**RE: Verdantas Project No. 37628
Storm Sewer Repairs
Clayton, Delaware
Pre-Bid Questions and Answers**

BID ADDENDUM NO. 1
STORM SEWER REPAIR
CLAYTON, DELAWARE

August 17, 2026

Exhibit A - Cured in Place Pipe Repair

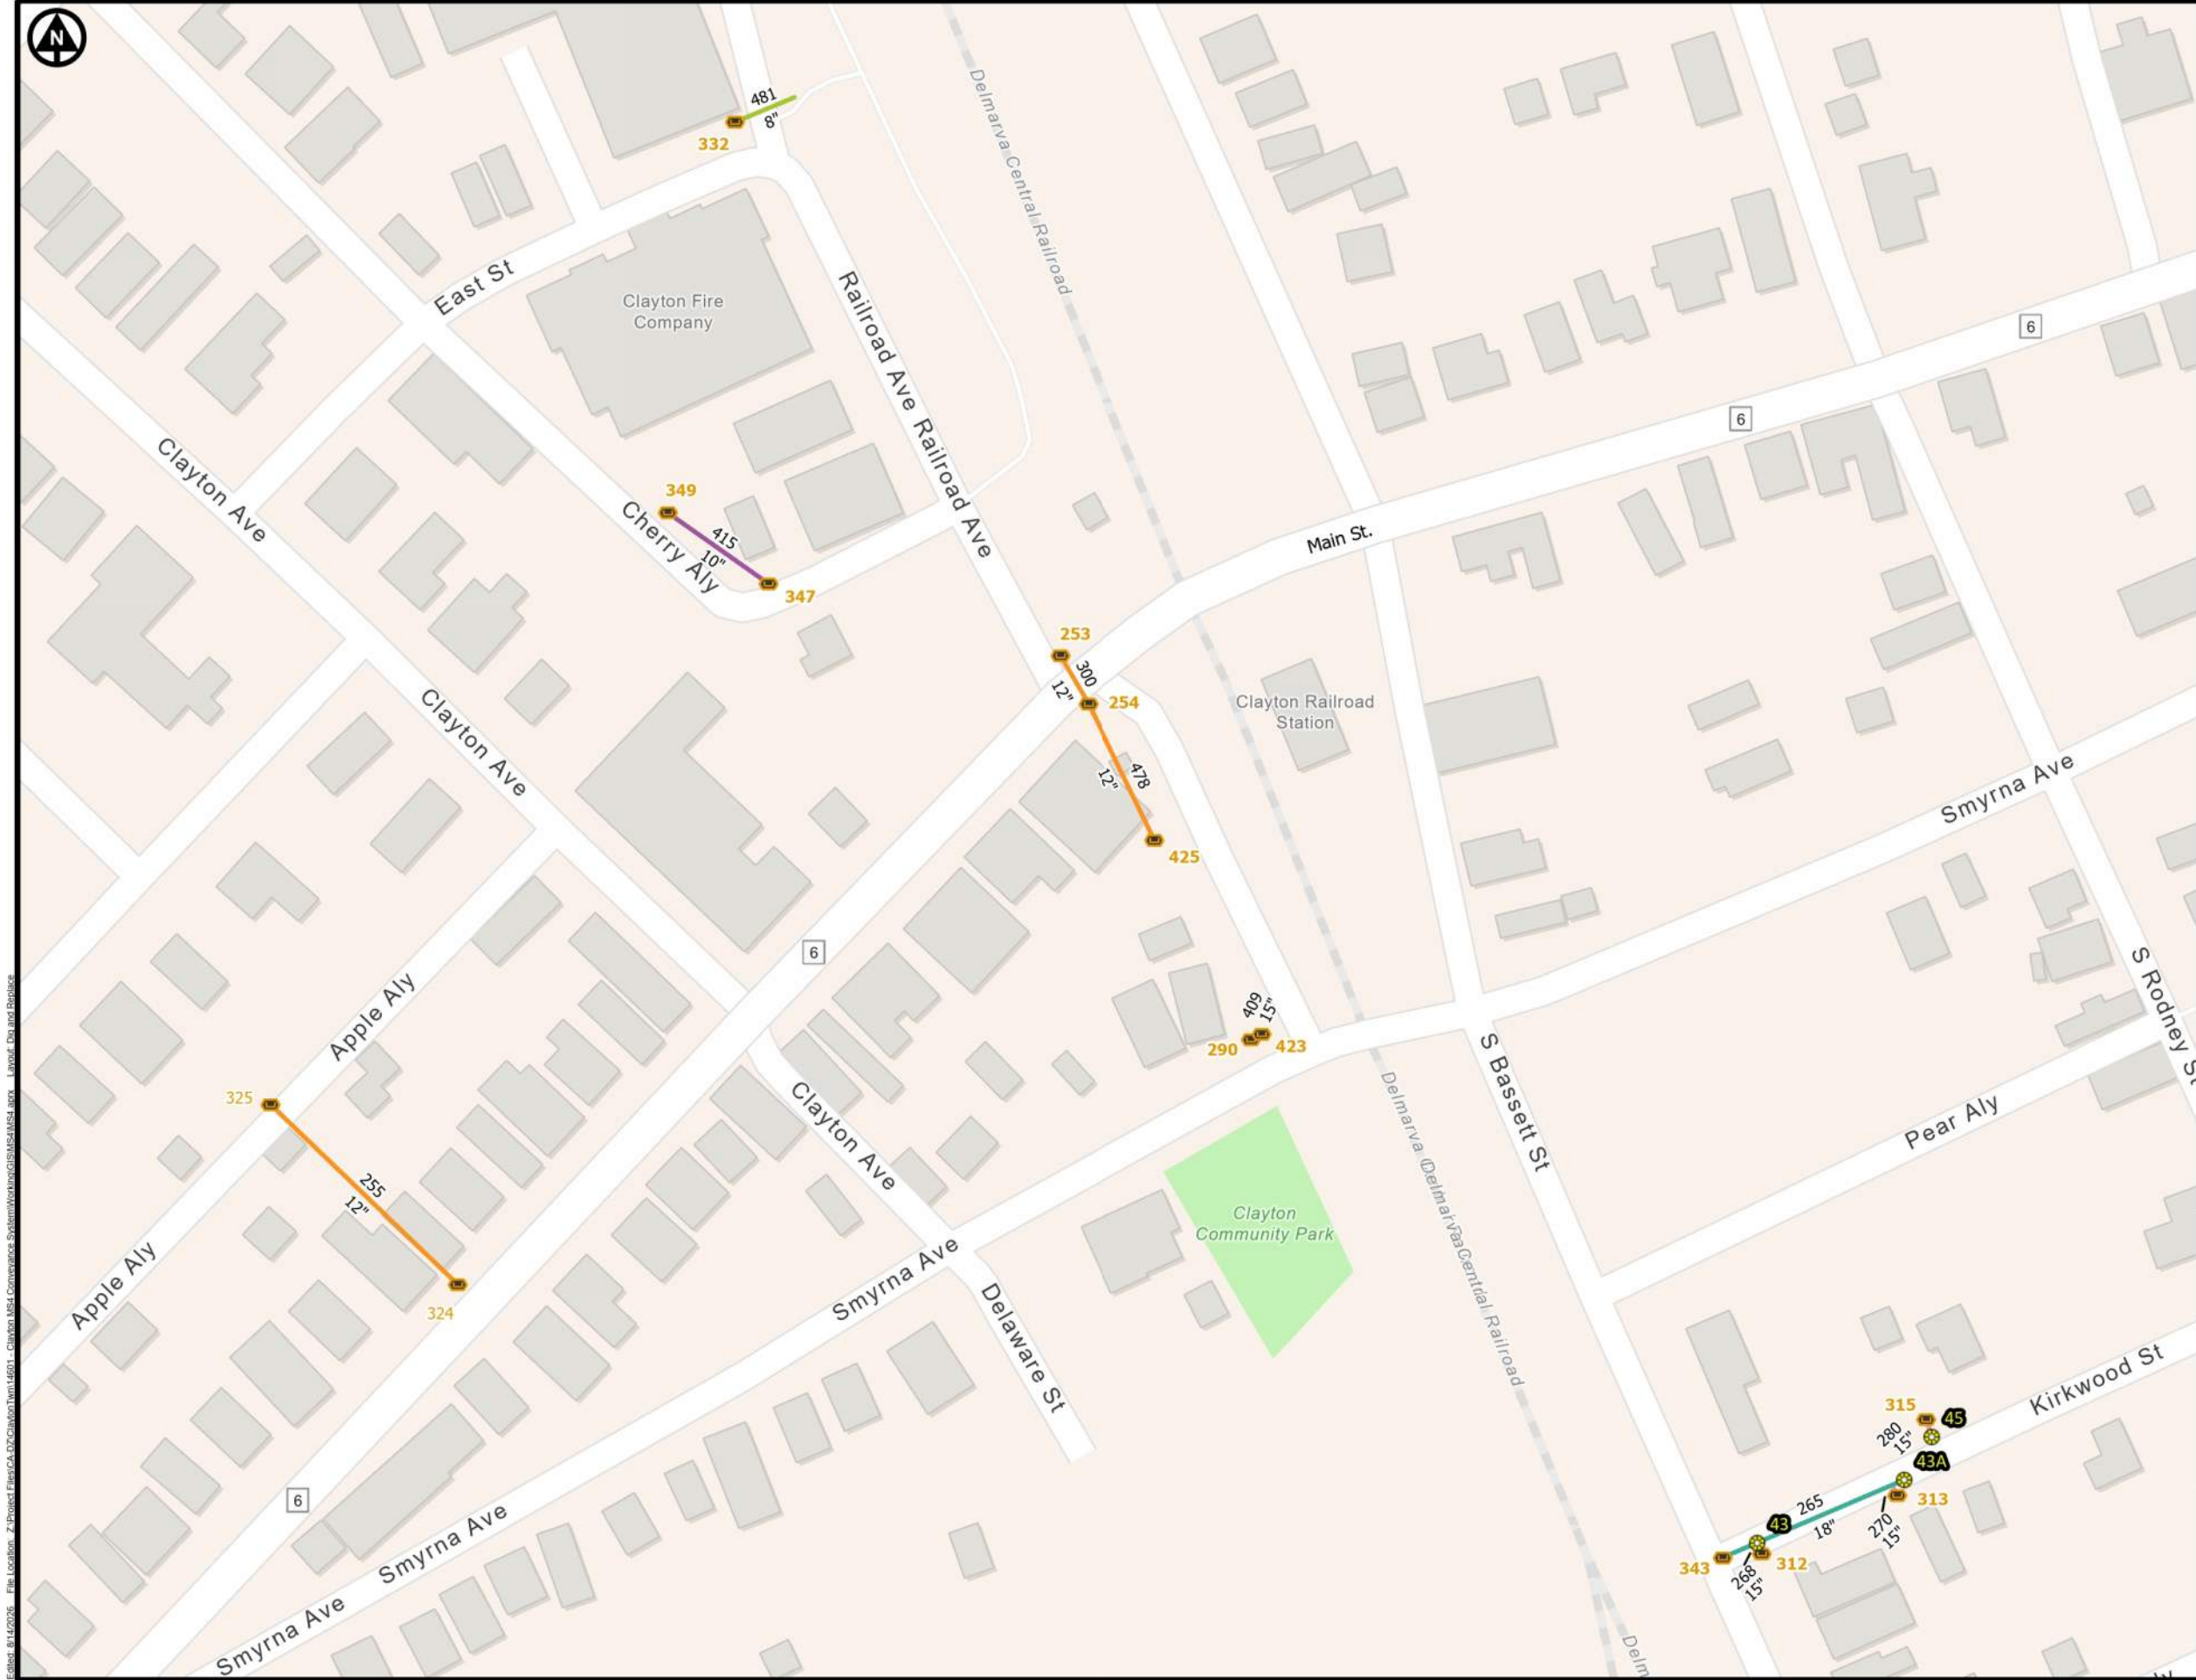
- 1) Delete: Bid for Unit Price and replace with the attached.**
- 2) Delete: Cured in Place Pipe Repair (Exhibit A) and replace with the attached.**
- 3) Delete: Storm Sewer Pipe Replacement (Exhibit B) and replace with the attached.**
